January 24, 2006
E-23180

Subject: Submittal of Formal Revision 4 of the NUHOMS® HD System Safety Analysis Report (TAC NO. L23738).

TN Response to NRC Peer Review Comments on the
NUHOMS[®] HD System

**NUHOMS HD Peer Review Comments
December 7, 2005**

Figure 3-2
Finite Element Model and Boundary Conditions WE 15x15 and WES 15x15

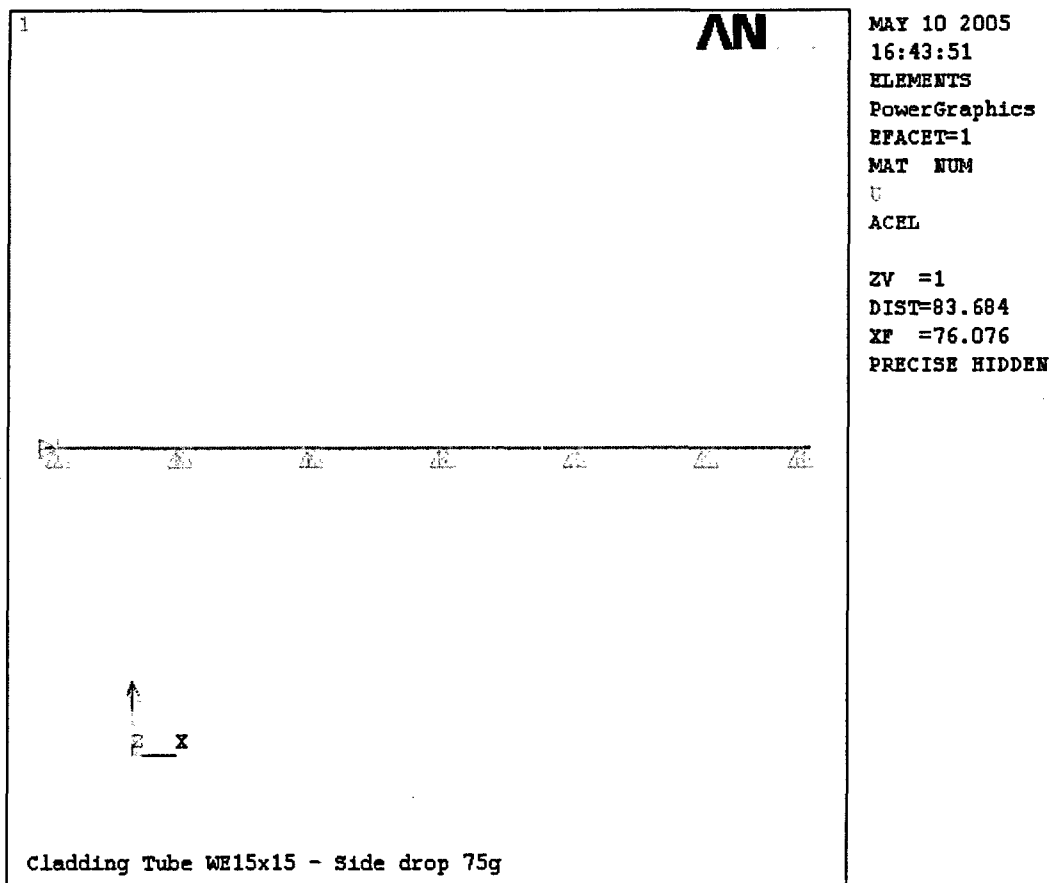
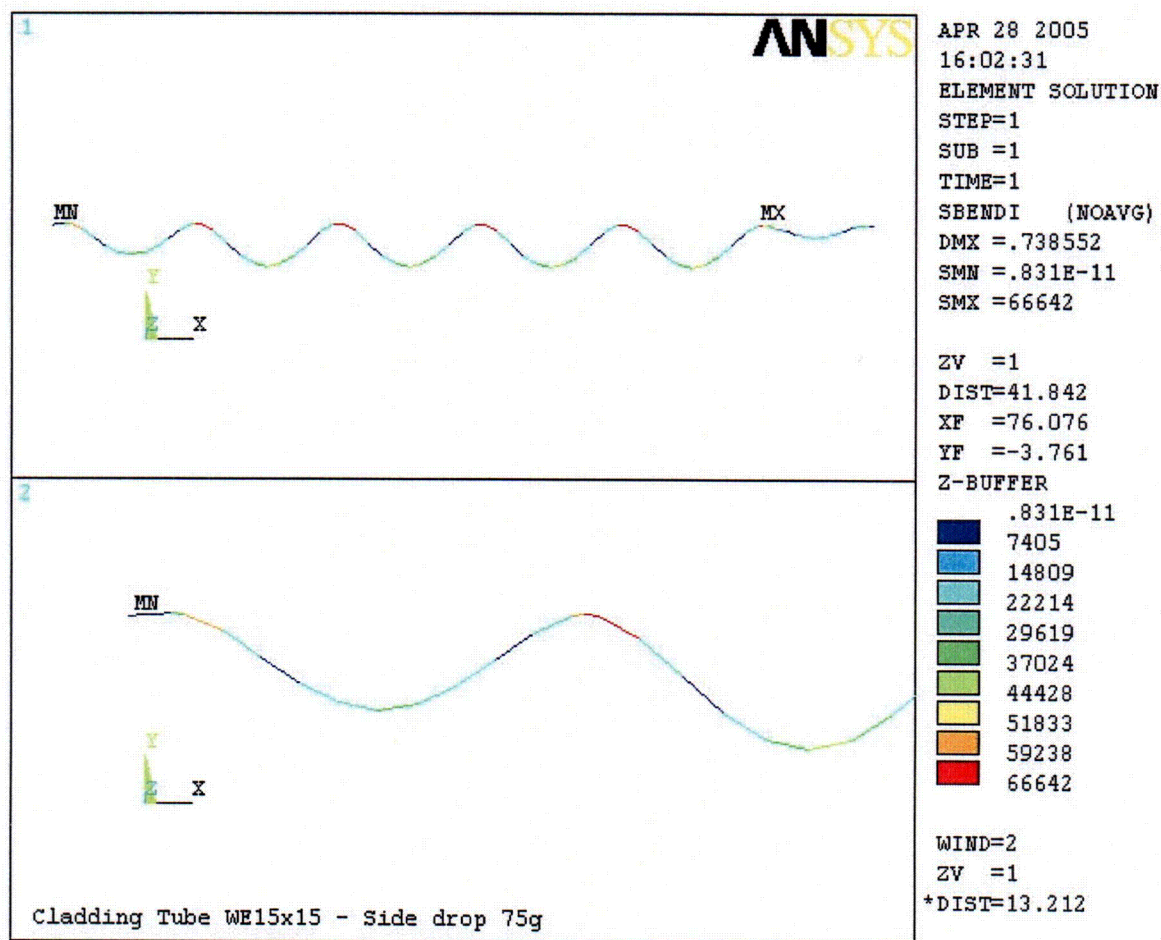
Table 3-13	Response to RAI#2 and consistent fuel type abbreviation call out (comment from Peer Review #1)
Figure 3-2	Response to RAI#2 and consistent fuel type abbreviation call out (comment from Peer Review #1)
Figure 3-3	Response to RAI#2 and consistent fuel type abbreviation call out (comment from Peer Review #1)
Figure 3-4	Response to RAI#2 and consistent fuel type abbreviation call out (comment from Peer Review #1)
Figure 3-5	Response to RAI#2 and consistent fuel type abbreviation call out (comment from Peer Review #1)
Figure 3-6	Response to RAI#2 and consistent fuel type abbreviation call out (comment from Peer Review #1)
Figure 3-7	Response to RAI#2 and consistent fuel type abbreviation call out (comment from Peer Review #1)

Figure 4-39
Comparison of the Axial Heat Profiles in the FE Model and in Ref. [4]

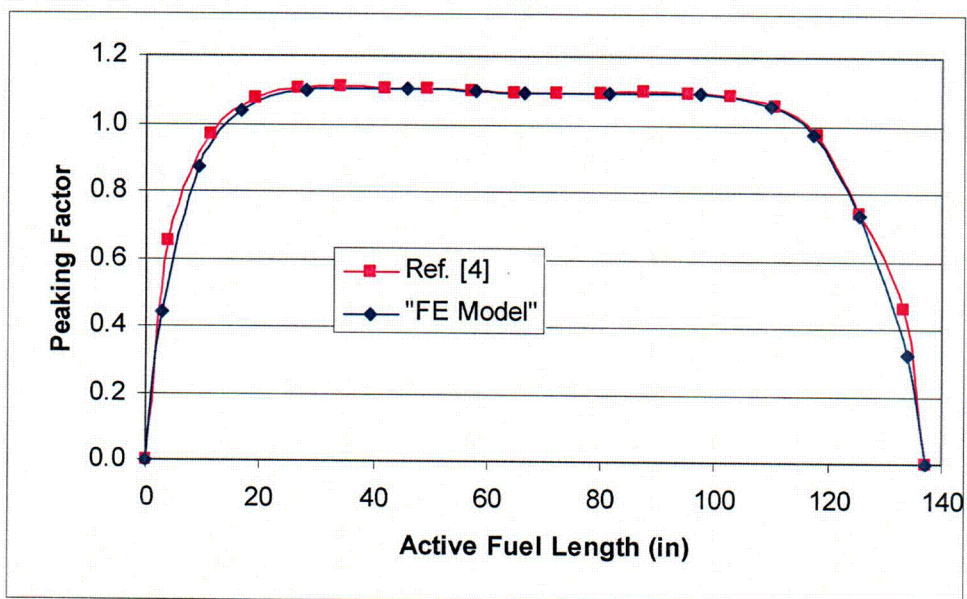
Figures 4-39, 4-47,	Consistent fuel type abbreviation call out (comment from Peer Review #1)
5-ii	Consistent fuel type abbreviation call out (comment from Peer Review #1), typo
5-1	Consistent fuel type abbreviation call out (comment from Peer Review #1)
5-3	Typo (change ENDFB-IV to ENDF/B-V)
5-4	Consistent with Technical Specifications and fuel type abbreviation call out (comment from Peer Review #1)
5-5	Typo (change ENDFB-IV to ENDF/B-V) and fuel type abbreviation call out (comment from Peer Review #1)
Table 5-7	Consistent fuel type abbreviation call out (comment from Peer Review #1)
Table 5-9	Consistent fuel type abbreviation call out (comment from Peer Review #1)
Table 5-10	Consistent fuel type abbreviation call out (comment from Peer Review #1)
Table 5-13	Consistent fuel type abbreviation call out (comment from Peer Review #1)
6-ii	Typo
Table 6-1	Consistent with Technical Specifications
Table 6-3	Consistent fuel type abbreviation call out (comment from Peer Review #1) and consistent with Technical Specifications

Figure 7-1
32PTH DSC Confinement Boundaries and Welds

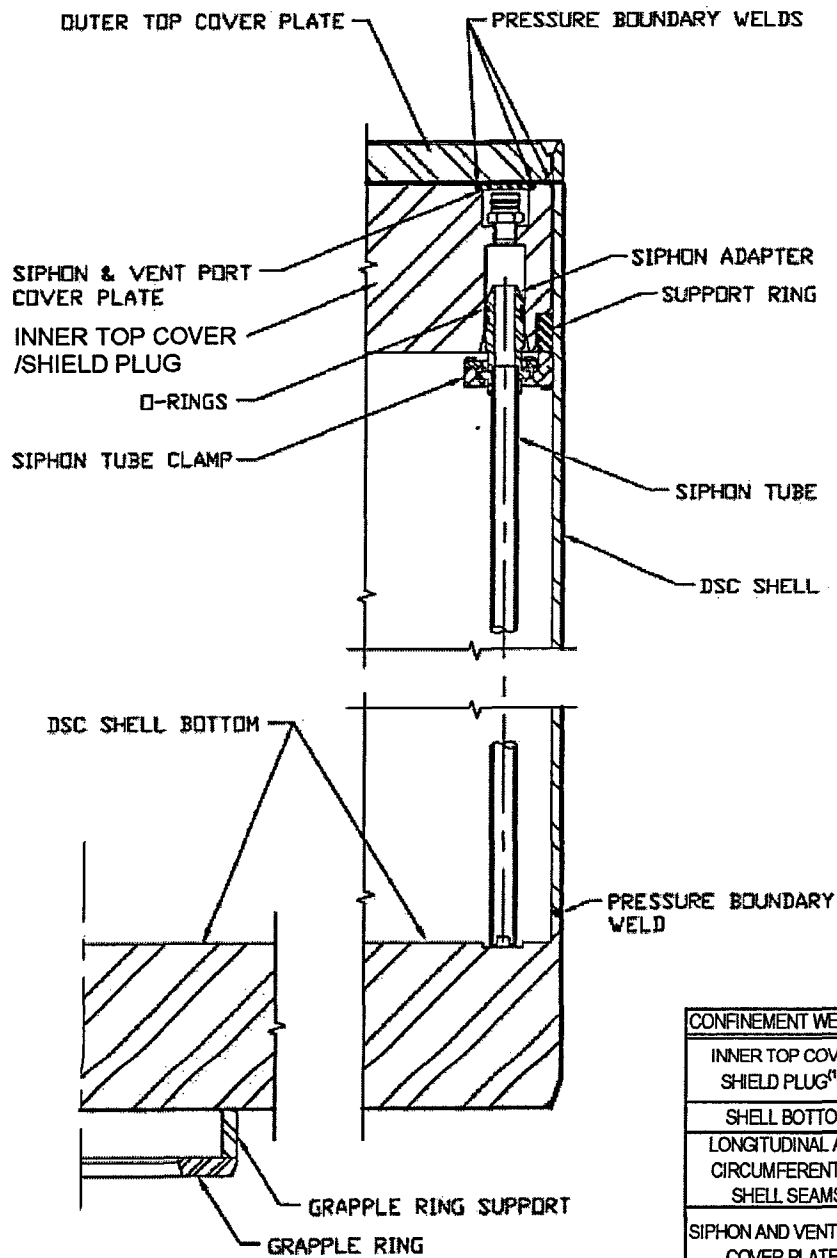
Page Number	Change Description and Reason for Change
7-5	Remove Code Case N-595-3 (comments from Peer Review #23 and #32)
Figure 7-1	Editorial change and add detail description of confinement boundary welds (Action per 11/18/05 telcon with NRC Staff)
8-1	Replace air with nitrogen; response to Peer Review Comment #15, typo
8-2	Response to Peer Review Comments #5 and #10
8-3	Replace air with nitrogen; response to Peer Review Comments #9 and #11; editorial change, add note 1
8-4	Replace air with nitrogen; response to Peer Review Comments #6, #15, and #35; editorial correction; terminology consistency
8-5	Response to Peer Review Comment #6; action per 11/18/05 telcon with NRC Staff for adding pressure test of inner cover/shield plug to shell weld; editorial changes
8-6	Replace air with nitrogen; Action per 11/18/05 telcon with NRC Staff; editorial correction; response to Peer Review Comments # 12 and #35

Figure 12-2
Heat Load Zones

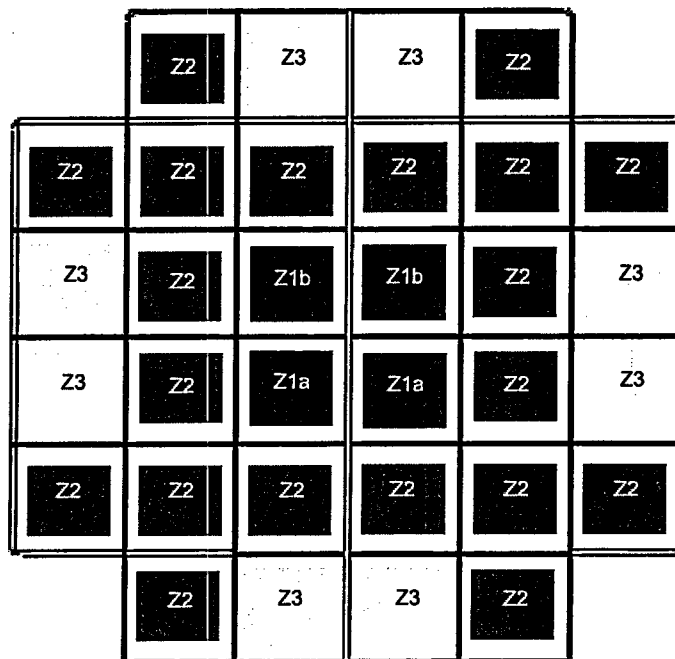
Page Number	Change Description and Reason for Change
Figure 12-2	Consistent with Technical Specifications
B12-9	Replace air with nitrogen
B12-10	Response to Peer Review Comment #6
B12-11	Replace air with nitrogen and clarity regarding "inner top cover/shield plug" for consistency
B12-13	"Annulus" deleted for consistency, an editorial correction, and clarity regarding "inner top cover/shield plug"
B12-14	"Annulus" deleted for consistency
Chapter 13 pages 13-i, 13-1, 13-2, 13-3, 13-5 through 13-8, 13-10, and Table 13-1	Consistent with current Quality Assurance Program Description Manual
